PLANNING AND ZONING BOARD STAFF REPORT

Delray Hyundai Genesis

Meeting	File No.	Application Type
October 20, 2025	2025-065	Level 3 Site Plan
Property Owner	Authorized Agent	
ABC JS Auto Imports LLC	Covelli Design Associates

Consideration of a Level 3 Site Plan Application with Architectural Elevations and Landscape Plan for an approximately 167,000 square foot full-service automotive dealership at 2612-2650 N. Federal Highway.

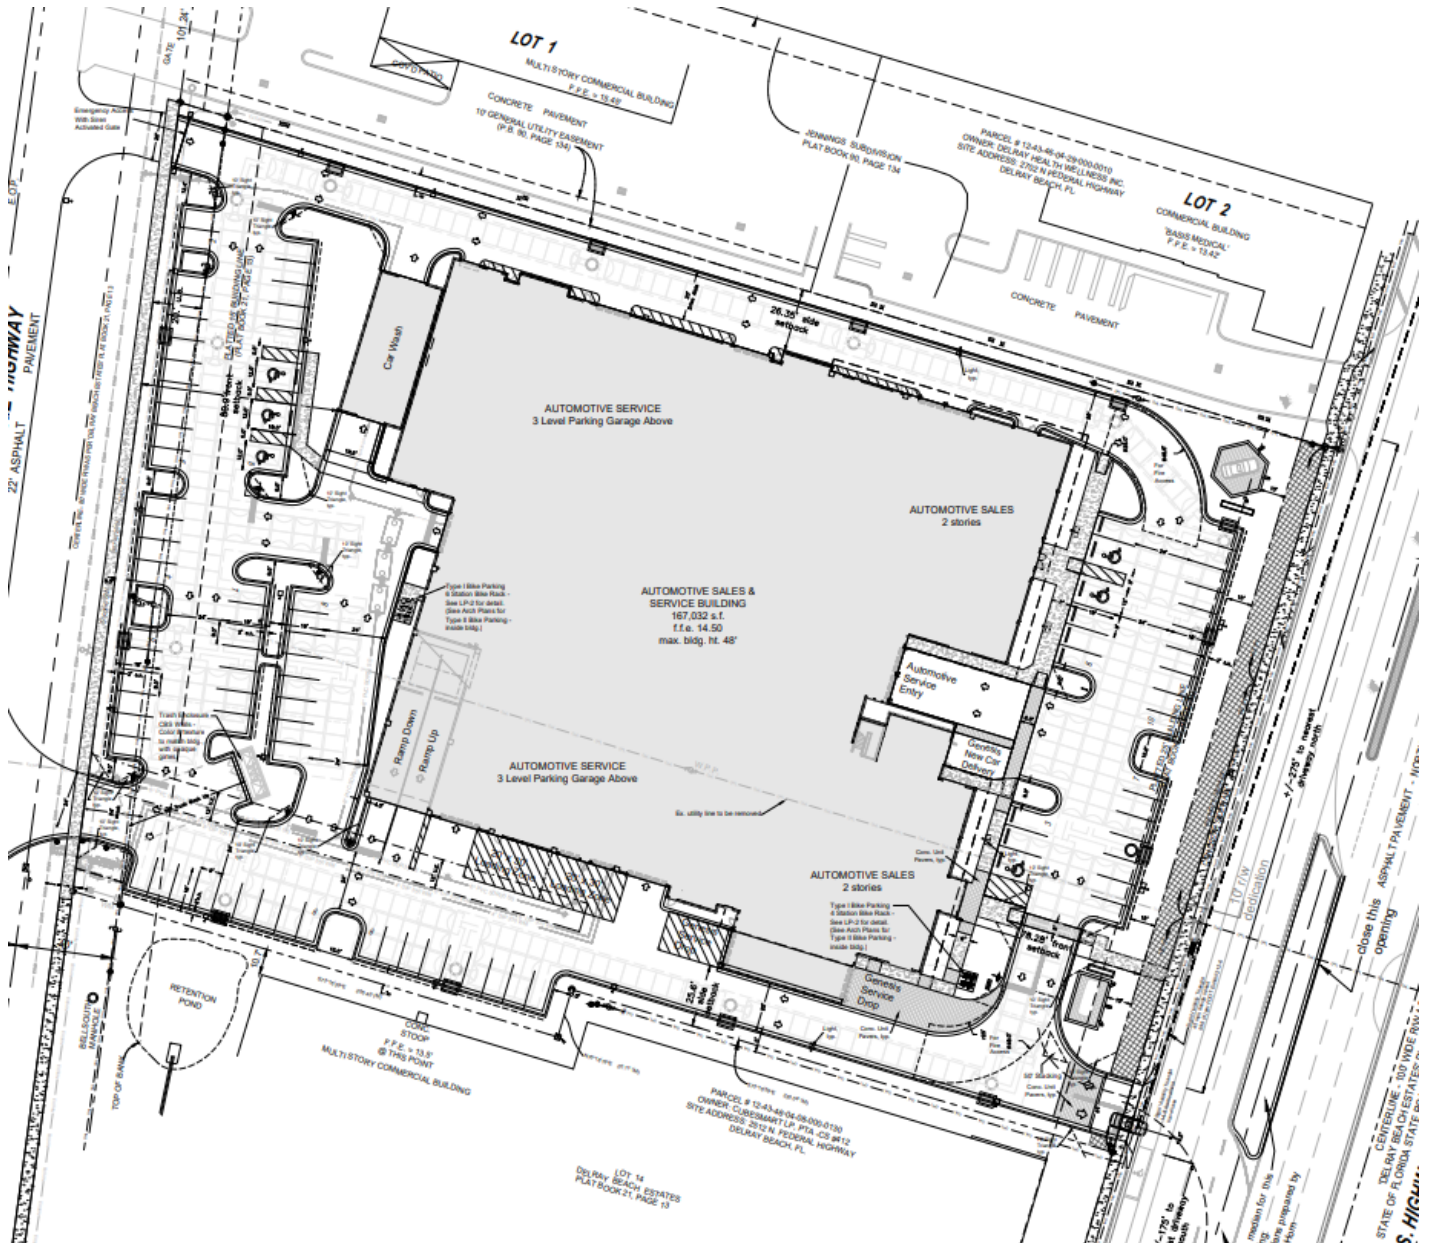
The architectural style proposed is contemporary and is reflective of the national brand prototyping. The centralized building is wrapped on all sides by vehicular use area (parking, drive-aisles, etc.) and the minimum required landscape buffering adjacent to vehicular use area, including the increased 10-foot buffer adjacent to Federal Highway, is provided along the full extent of the site.

Parking is provided via a surface lot (88 spaces) and parking garage (237 spaces) for a total of 325 spaces. 153 of these spaces are required to remain allocated for customer and employee parking and any surplus parking may be used for vehicle inventory storage.

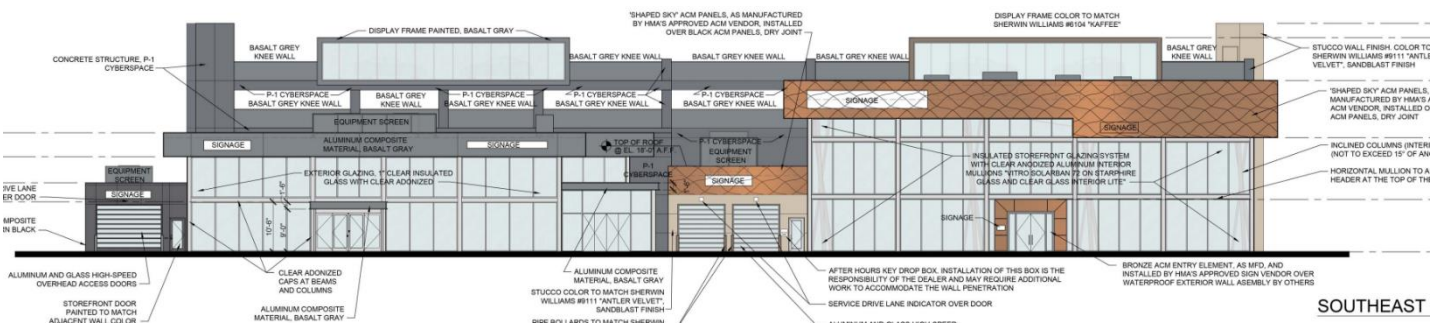
Staff finds that the design criteria are met. The contemporary design is aligned with the national brand prototype. The façade integrates material and texture variation to create interest, and there are various points of vertical articulation and shifts in the massing that move the design beyond what could otherwise be a repetitive and bland product.

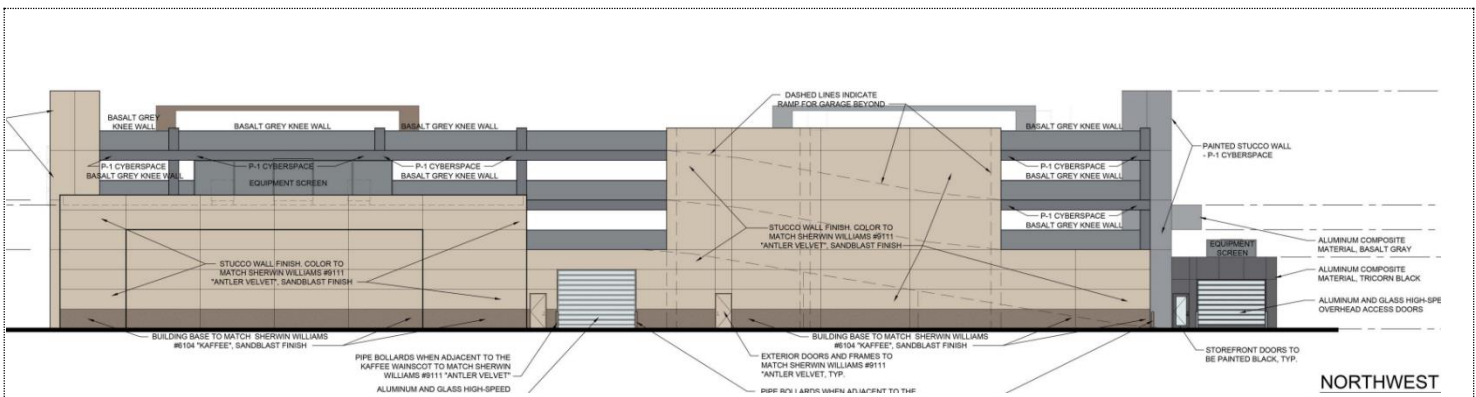
Staff worked with the Applicant during technical review to facilitate an improved exterior to the parking garage, and while improvements have been made through the introduction of raised stucco and scoring, as well as color palette variation, more interesting screening materials could still be introduced to the garage to allow it to match the quality of the front façade.
